EGUSPHERE-2025-3175

**Review of the manuscript „The TropoPause Composition TOwed Sensor Shuttle (TPC-TOSS): A new airborne dual platform approach for atmospheric composition measurements at the tropopause“**

Reply to referee #1

Reply to referee #2

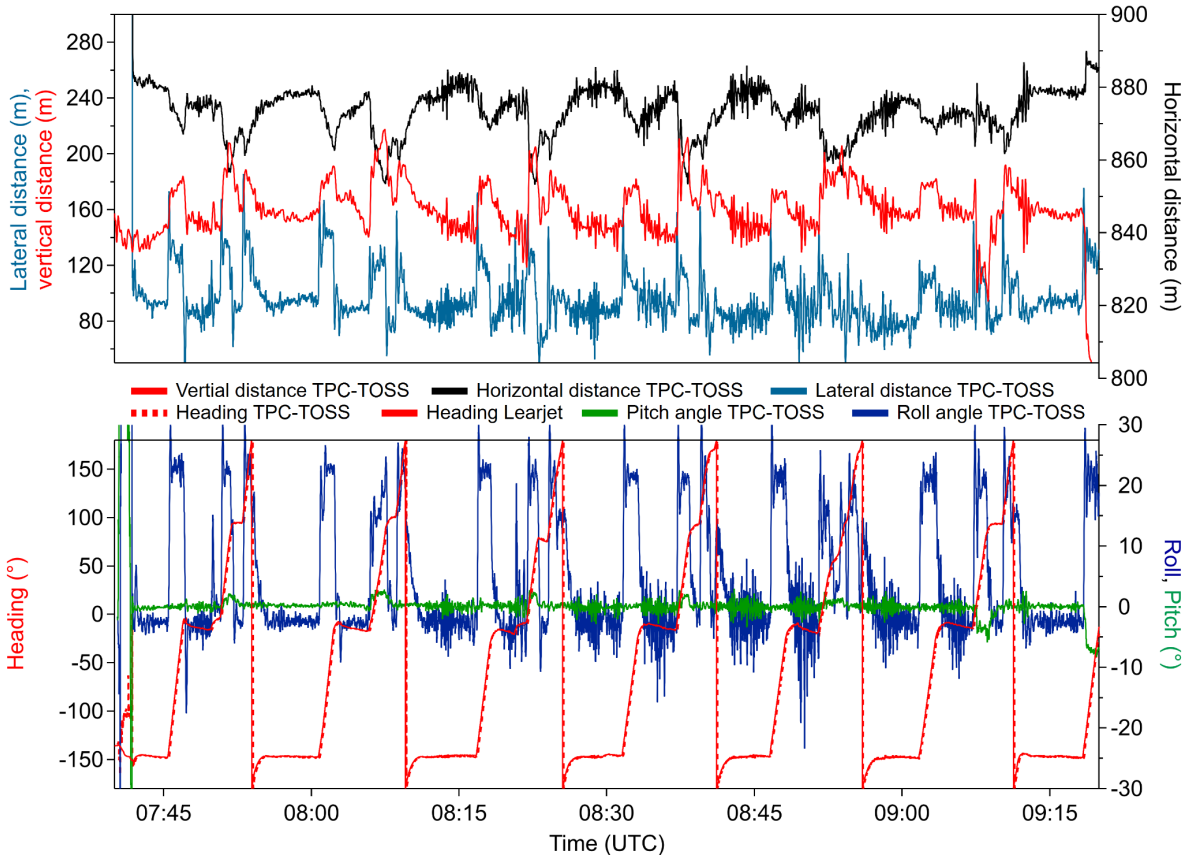
- Please state on the swinging behaviour of the system, e.g. show statistics on pitch/roll/yaw angles during one flight, mention critical situations, describe more

in detail how the tethered system is handled, e.g. with a winch. There is some information in the summary (900 m behind, 200 m lateral) – how constant is this?

The TPC-TOSS is flying quite stable during undisturbed flight conditions (without turns and altitude changes). During these conditions the following statistics are given as mean values and standard deviation over flight F10 (see figure below):

- Altitude difference between Learjet and TPC-TOSS: 152.3 +- 8.3 m
- Pitch angle: -0.02 +- 0.60 °
- Roll angle: -2.52 +- 2.35 °
- Horizontal distance between Learjet and TPC-TOSS: 877.2 +- 3.1 m
- Lateral distance between Learjet and TPC-TOSS: 88.7 +- 8.2 m

Deviations from these undisturbed flight conditions occur during altitude changes and turns. Altitude changes of Learjet and TPC-TOSS are indicated by a higher pitch angle during climb or a lower pitch angle during descent in Fig 1., turns are indicated by a change in the Learjet and TPC-TOSS heading. These are accompanied by significantly higher roll angles of the TPC-TOSS following the

turn until it is in stable flight mode after a few seconds. For the particular flight larger variations in the roll angle along part of the horizontal flight sections are visible. These are mainly caused by turbulence occurrence during the flight. Notably, none of these deviations from undisturbed flight conditions significantly affect trace gas and aerosol measurements as discussed in Fig 14 in the preprint.

Critical situations during the flight in general arise from turns as these add additional force to the rope and too sharp turns might lead to a rupture in the wire rope.

To further analyse the oscillating behaviour of the TPC-TOSS we performed frequency analysis of the attitude parameters of TPC-TOSS but could not identify regular oscillations in these parameters. There are some flight intervals for which the frequency analyses indicate oscillations with a period of around 20 s of unspecific origins. However, measurements were not affected by these oscillations.
